# Technical Bulletin

DP02	TB0004-2006	Elan Motorsports Technologies	
<b>From:</b>	Chip Lewis		
<b>Subject:</b>	Rear Light Harness	<b>Date:</b>	September 15 <sup>th</sup> , 2006

## Attention all Elan DP02 2006 teams

Picture 1- Overview of Harness & Tools (Arrow shows location of pin numbers)

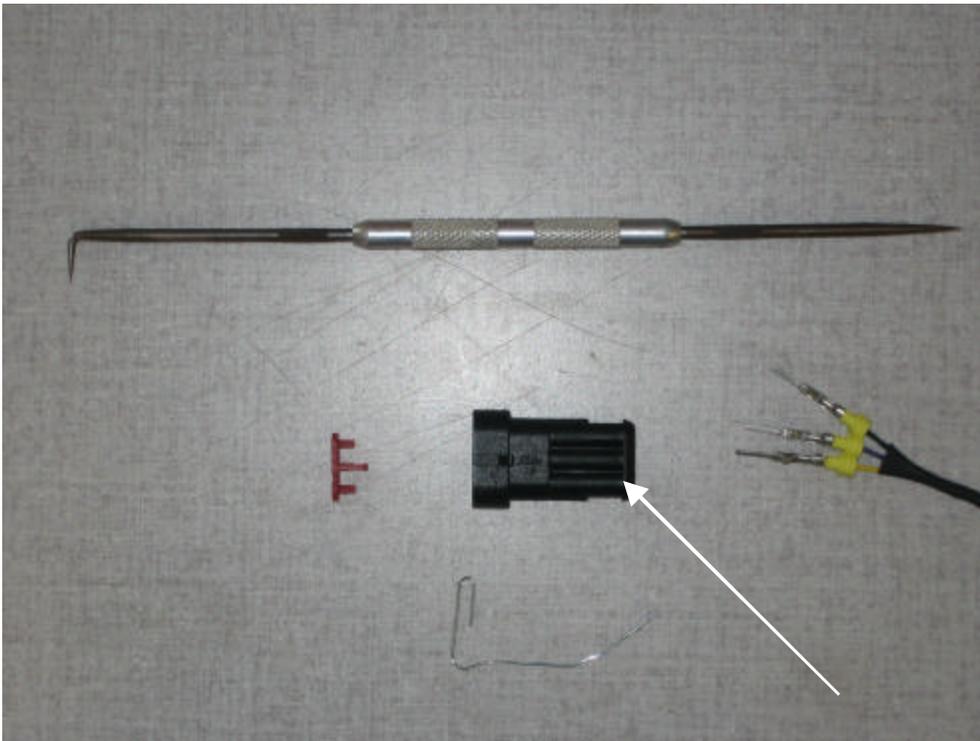
Elan Motorsports Technologies has identified an issue with certain tail light harnesses. Some tail light harnesses are wired incorrectly, resulting in improper light function. Your harness can be checked very quickly for correct specification. If you find that your harness is incorrect, please follow the directions below to correct the problem. You will find the pin numbers molded into the top of the connector

Pin	Correct Schematic	Incorrect Schematic
1	Yellow	Black
2	Purple	Purple
3	Black	Yellow

**Picture 2 - Red Cover (Removed)**

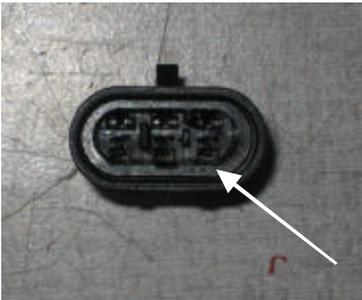
1. Remove the tail light harness from the rear bodywork
2. You will need a pick (Shown above with a straight bent end) and a paperclip
3. First remove the red internal cover, inside the connector
  - a. To remove the cover you will need to press a paperclip down one side, where the tang is located
  - b. With the paperclip in place use the bent end of a pick in the access hole in the middle of the red cover, to gently pry the cover out.
